Subject: Docket 50-206
Safety Injection System Modifications
San Onofre Nuclear Generating Station
Unit 1

SAFETY INJECTION SYSTEM MODIFICATIONS
SAN ONOFRE NUCLEAR GENERATING STATION, UNIT 1
SI PUMPS DEDICATION/NEW FEEDWATER PUMPS
CONCEPTUAL DESIGN INFORMATION

FIG. 2. MODIFICATIONS TO THE EXISTING PIPING AND THE NEW FEEDWATER PUMP ARRANGEMENT (TYPICAL FOR BOTH TRAINS EXCEPT AS NOTED.)

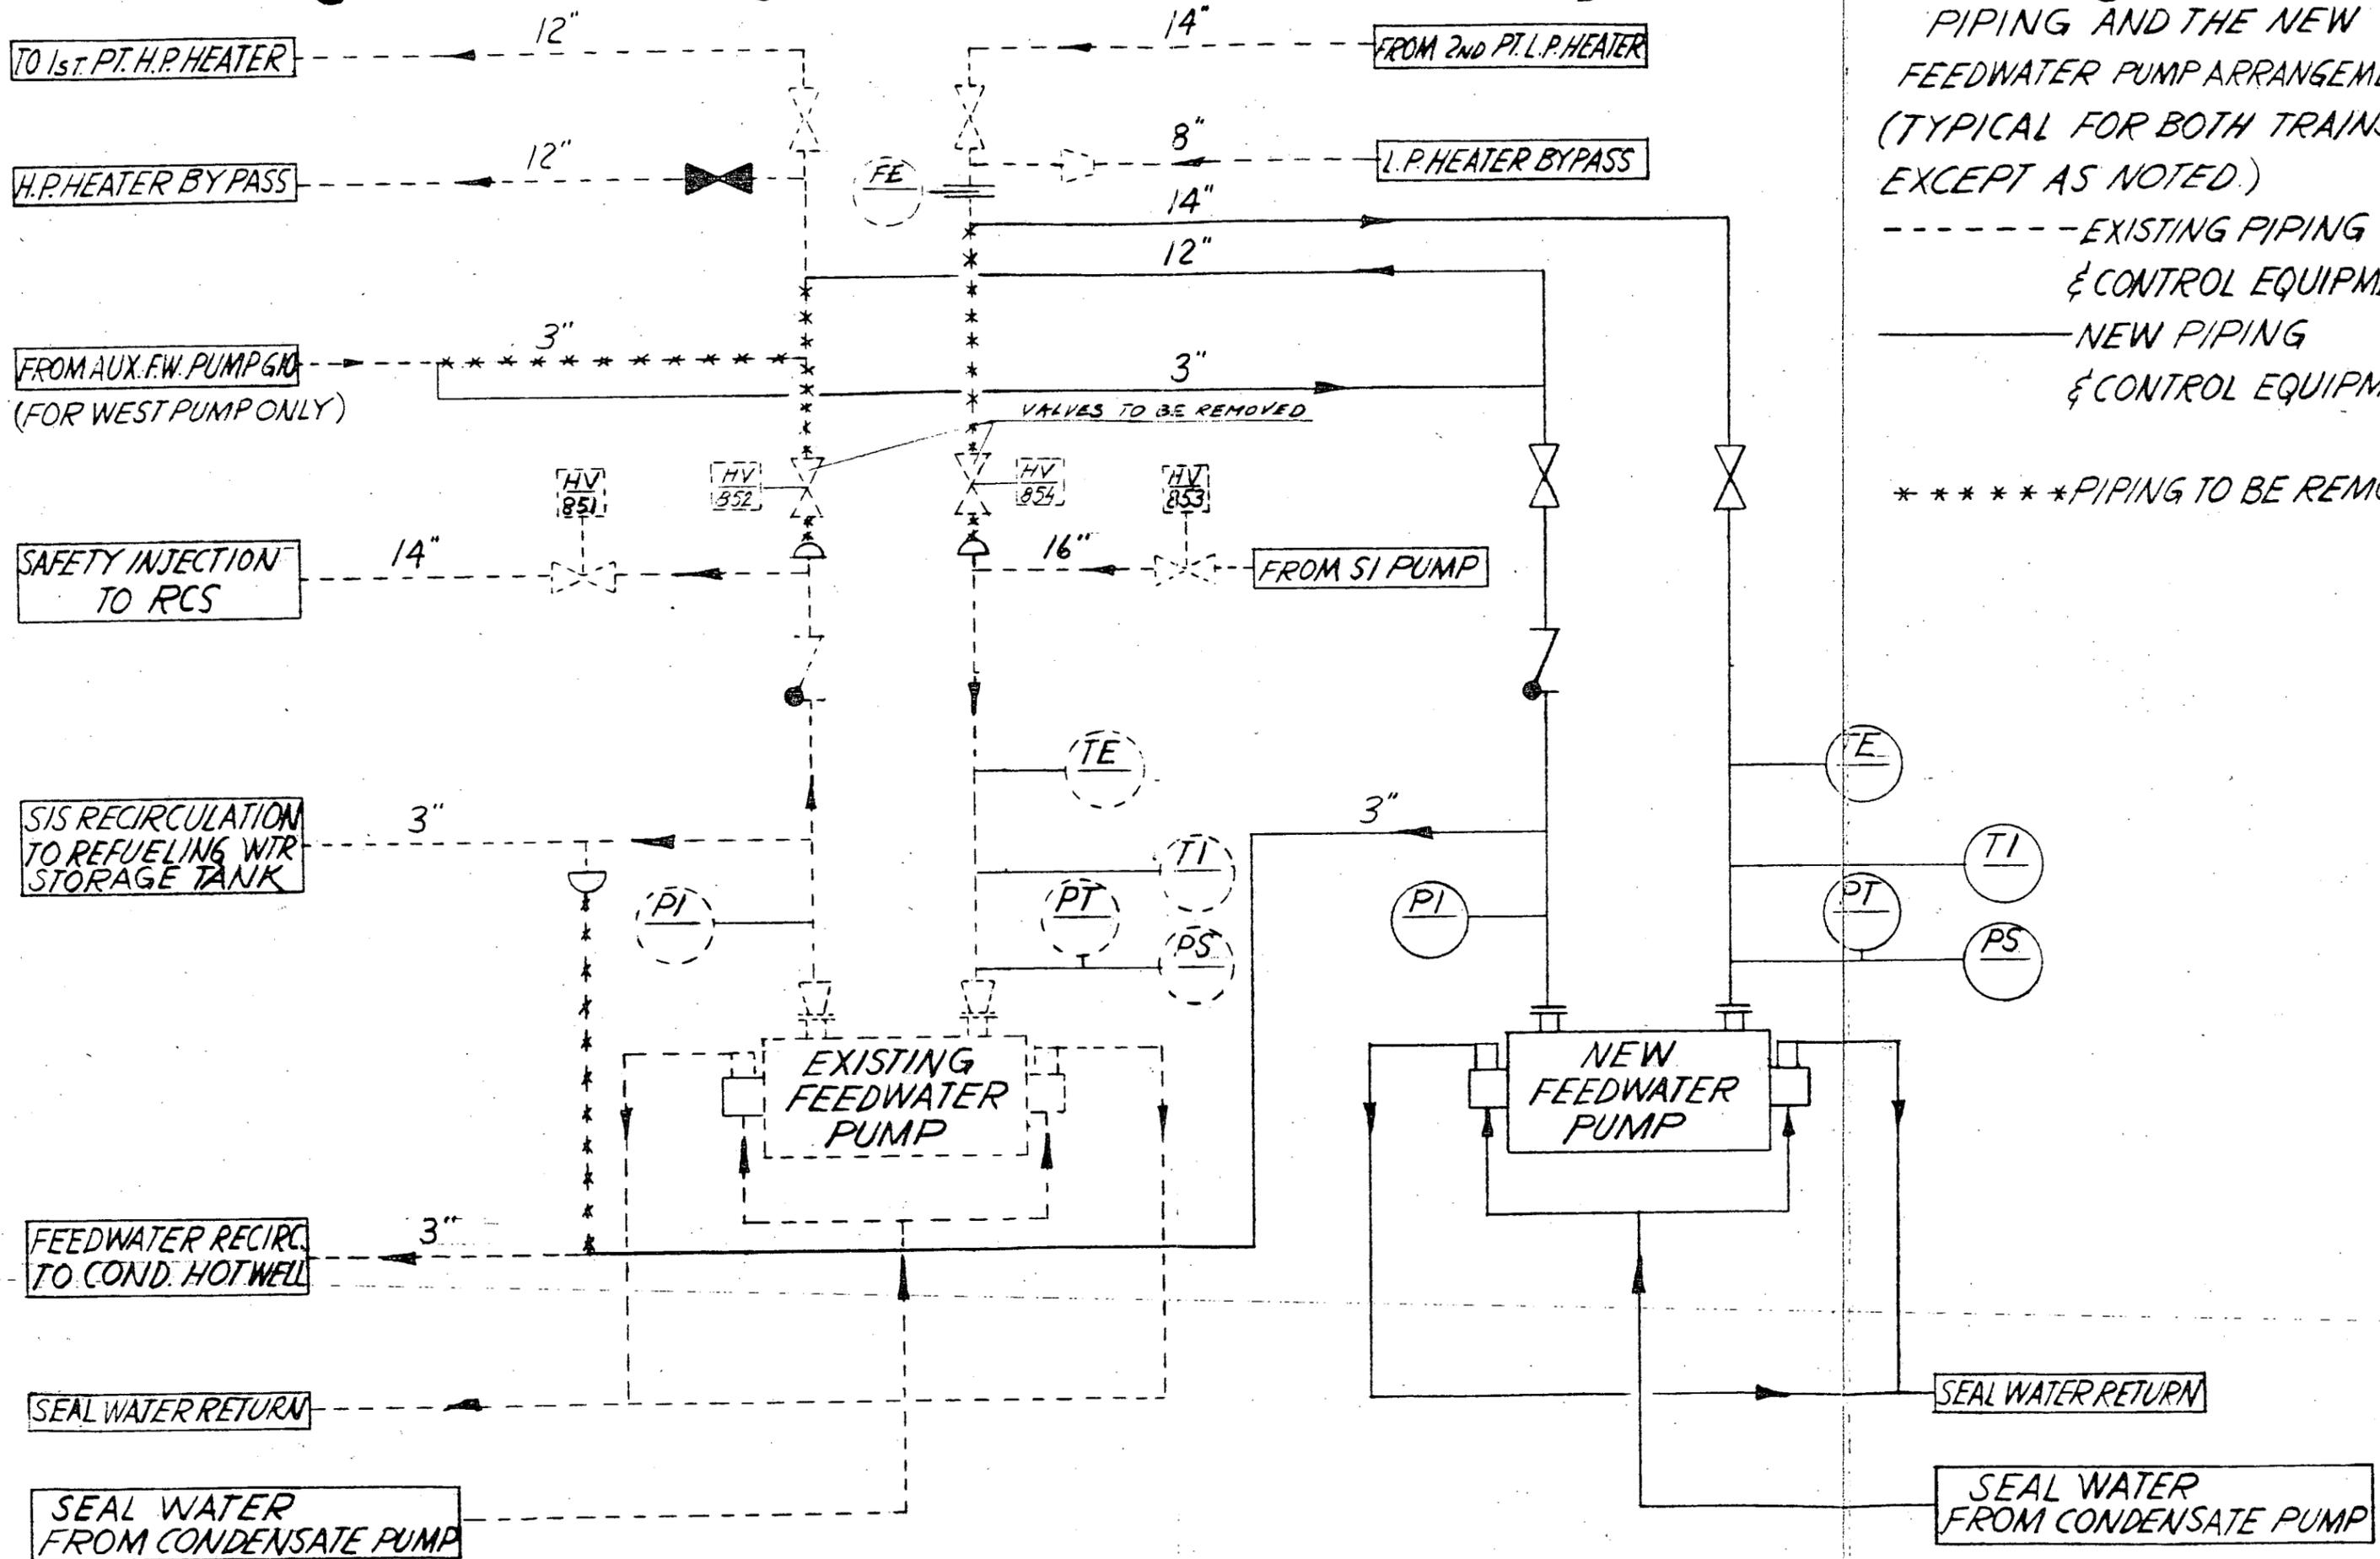
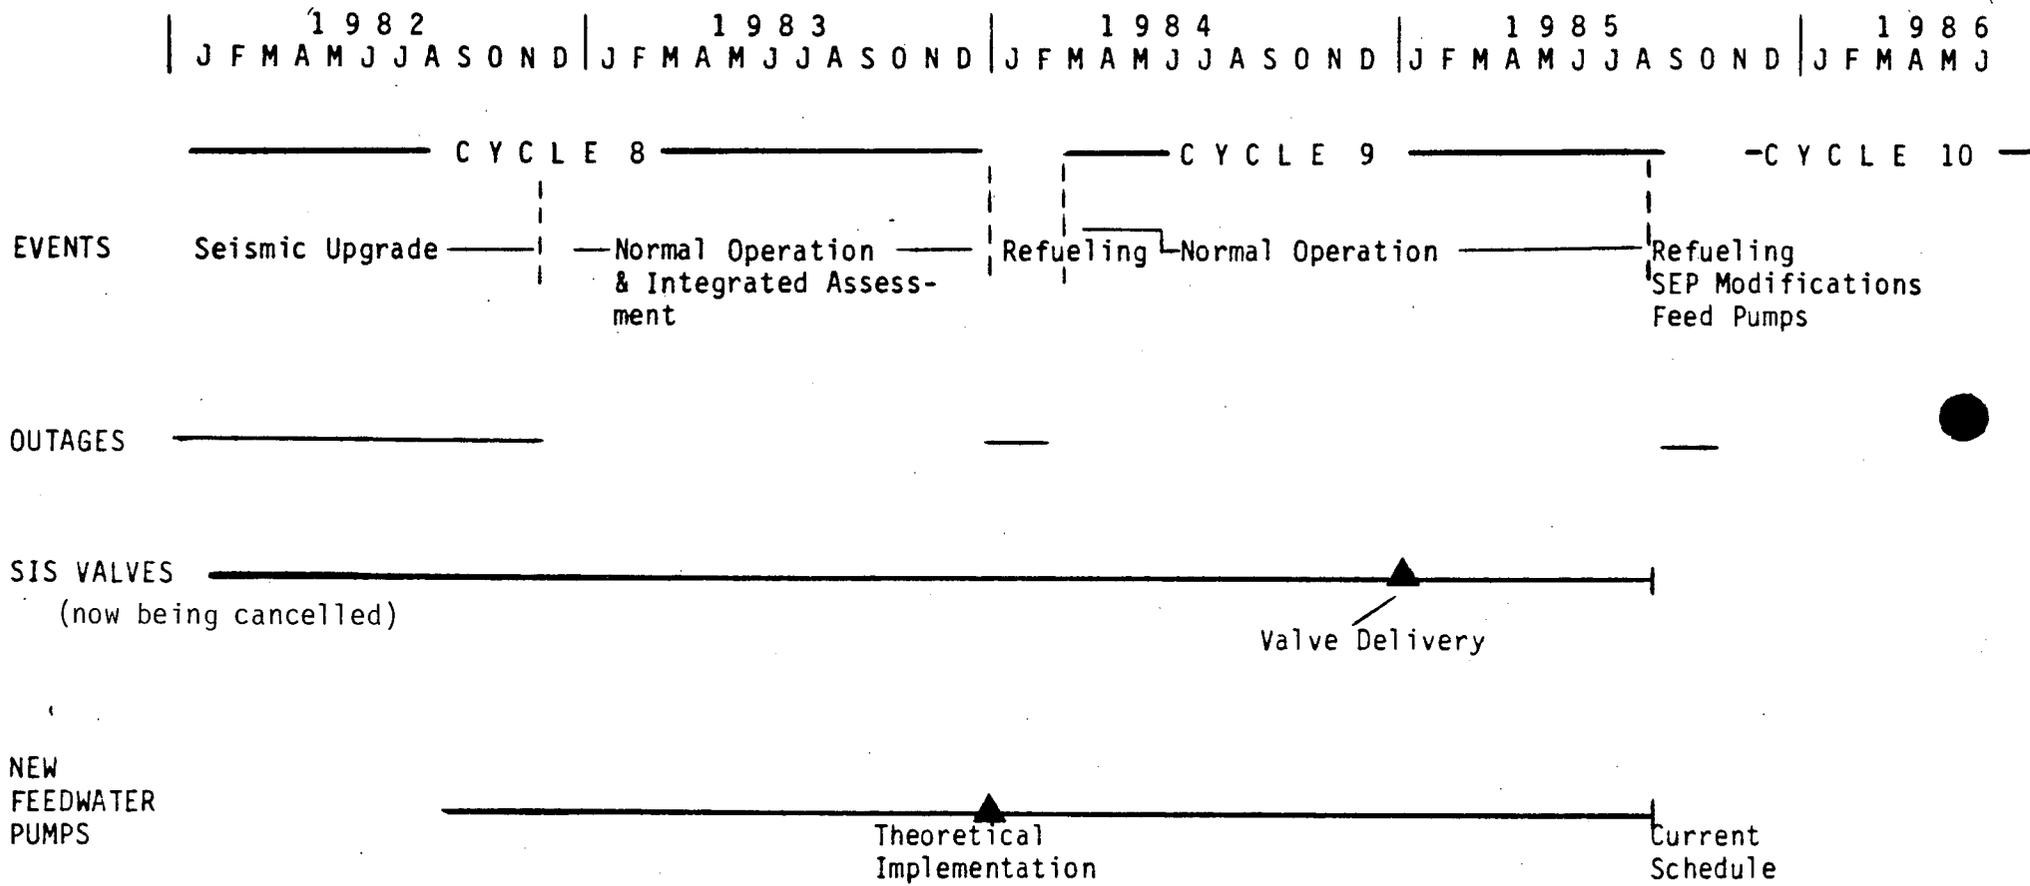
Figure 2 shows the proposed modifications to the existing piping and the new feedwater pump arrangement. Additional piping, isolation valves (HV-852 and HV-854 valves may be salvaged for this purpose), and check valves for the new feedwater pumps will be required. The low pressure and the high pressure heater bypass connections, located upstream and downstream of the existing feedwater pumps, and the flow elements (FE13 and 14) for both east and west feedwater trains will be left intact. The feedwater recirculation lines will be rerouted to the new pumps. For the west feedwater train, the manual auxiliary feedwater flow path connection will be relocated.
